Subject: Product Upgrade Notice of Dust Sensor

SM-PWM-01A dust sensor has been successfully upgraded and the new part No. is SM-PWM-01C. SM-PWM-01A had been all stopped production since Jan.1, 2016.

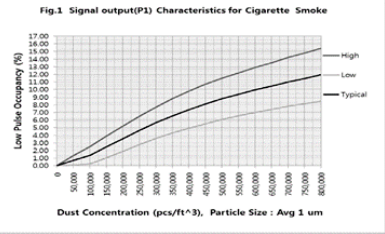
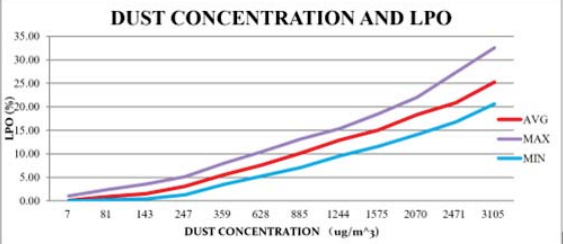
The detailed differences between SM-PWM-01A and SM-PWM-01C are as below chart:

SM-PWM-01A	SM-PWM-01C
Appearance		
Output Characteristics		
Supply Voltage Ripple	< 100mV	<200mV, less disturbance when working with other components powered by the same source
Size (WxHxD) & Weight	59 x 46 x 18 mm 23g	59 x 46 x 18 mm 20g
Connector & Pins		No Change
